# Access Compliance Report

## Public Rights-of-Way

### (Curb Ramps)

Intersection ID: 49131	Main Street: EWERT_CUT_LN	Cross Street: WILTSHIRE_RIDGE_RD	Location: SE
ADA ID: 02A7321915EF	Ramp Type: Perp	Initial Pass/Fail: Pass	Overall Compliance: No
Codes/Mitigation Info/Possible Solution		Field Measurements/Component Compliance	
Severity Score: 2.5

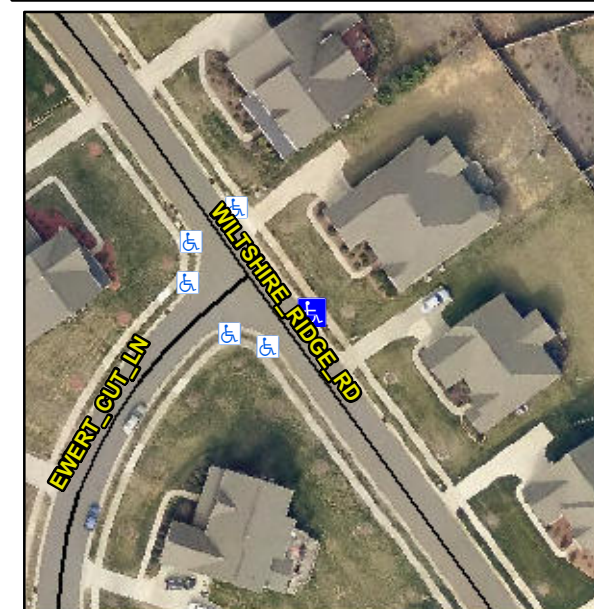
**Not Found, R304.2.1, R304.2.2-Perp, R304.3.2-Para, R304.2.3, R305.2**

Compliance	Description	Data	Compliance	Description	Data
N/A	Ramp Length (in)	46.5	Yes	Ramp Slope (%)	6.9
Yes	Ramp Width (in)	48.0	Yes	Ramp XSlope (%)	0.7
N/A	Flare Type LT	Sloped	N/A	Flare Type RT	N/A
N/A	Flare Slope LT (%)	10.2	Yes	Flare Slope RT (%)	2.8
N/A	Flare Traversable LT?	Yes	N/A	Flare Traversable RT?	Yes
No	Landing Length (in)	47.5	Yes	DWS Provided?	Yes
Yes	Landing Width (in)	50.0	Yes	DWS Contrast?	Yes
No	Landing Slope (%)	3.5	Yes	DWS Length (in)	24.5
Yes	Landing X Slope (%)	3.1	Yes	DWS Full Width?	Yes
N/A	Landing Curb? (Y/N)	No	No	DWS Offset (in)	4.0
N/A	Shared Landing?	No			
Yes	Gutter Ponding?	No	Yes	Gutter Slope (%)	2.9
Yes	Gutter Lip Ht (in)	0.0	Yes	Gutter X Slope (%)	3.6
N/A	Painted X Walk1?	No	N/A	Painted X Walk2?	N/A
	X Walk 1 Direction	To W		X Walk 2 Direction	N/A
N/A	X Walk 1 Width (in)	N/A	N/A	X Walk 2 Width (in)	N/A
	X Walk 1 Slope (%)	3.3		X Walk 2 Slope (%)	N/A
	X Walk 1 X Slope (%)	4.9		X Walk 2 X Slope (%)	N/A

N/A	Ramp inside XWalk1?	N/A	N/A	Ramp inside XWalk2?	N/A
	Road Slope (%)	N/A	N/A	Clear Space?	Yes
	Road X Slope (%)	N/A	N/A	Clear Space to XWalk (in)	N/A
Yes	Any Obstructions?	No	Yes	Storm Grate/Utility Hazard?	No
	Obstruction Type			Storm Grate/Utility Type	
		N/A			N/A
			Yes	Surface Condition? (G/P)	Good

**Remove & Replace Entire Ramp.**
